Access Compliance Report Public Rights-of-Way (Pedestrian Signals)

Main Street: **ANTONIO_PKWY** Cross Street: **CROWN_VALLEY_PKWY** Location: **E**

ADA ID: **SGRK211022141311** Signal Type: **One Push Button-Non APS** Overall Compliance: **No** Severity Scores: **BTN 1: 35** **BTN 2: N/A** **No BTN: N/A**

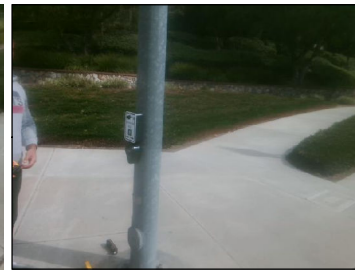
OC Std/PROW: R404.2, MUTCD 4e.08

Possible Solutions: Replace Signal Push Button With APS Button. Remove and Replace Clear Space.
